| REQUEST FOR INFORMATION NOT ADDRESSED IN THIS CCO REMAIN IN FORCE | | | | | |
|---|---|---|---|---|---|
| 0 | 03/08/10 | MEP INTEGRATION | SYC | FW | 110 |

CONTRACT CHANGE ORDER NO._____
SHEET _____ OF _____

# DETAILS
## BRIDGE STRUCTURES GIRDER WESTBOUND
## SKYWAY STRUCTURES-HINGE DW

**E-653**

## PLAN - HINGE DW

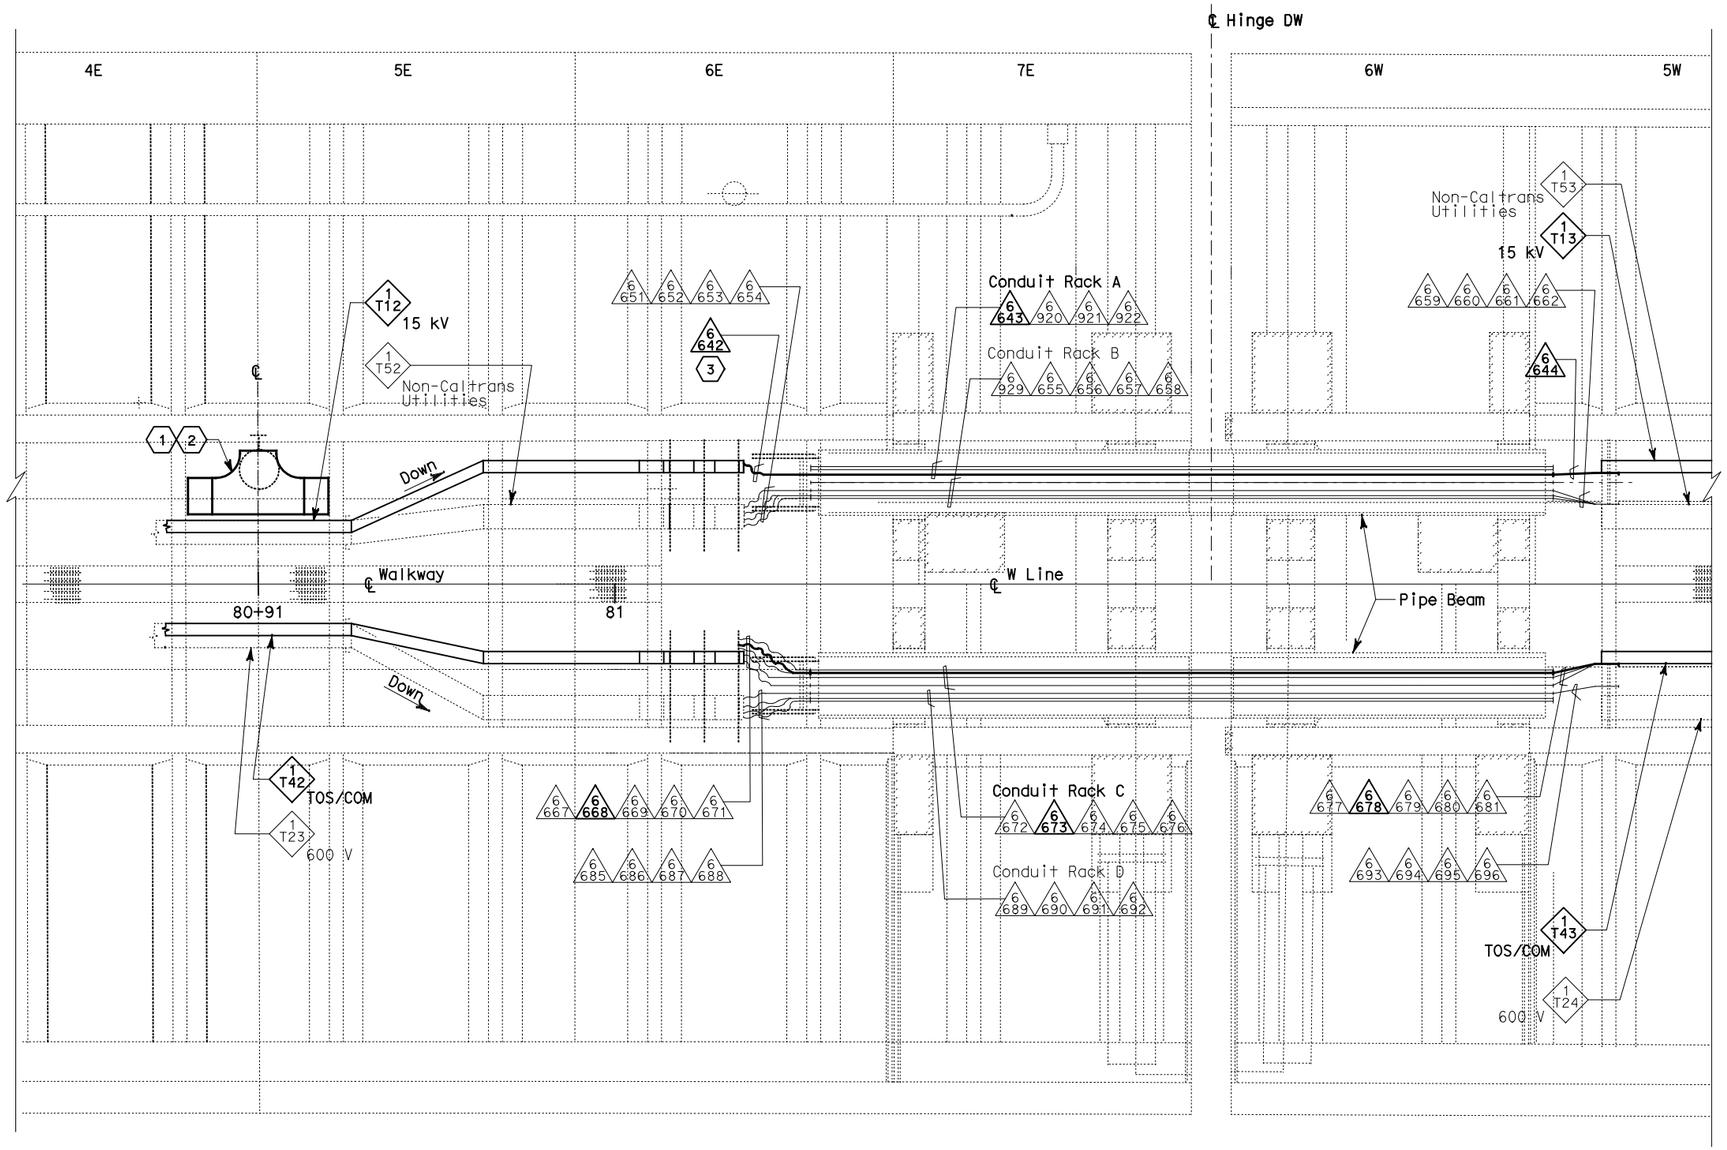
(1) Furnish and install splice cable tray as shown on sheet E-663, plan detail 1.

(2) Mount splice cable tray between diaphragms at Station 80+91 as shown on sheet E-614, and secure properly. See sheet E-663, section detail 4.

(3) In order to be able to pull the 15kV cable, the Contractor shall disassemble the 15kV flexible conduit installation. The 15kV flexible conduit shall be reinstalled after the 15kV cable has been installed.
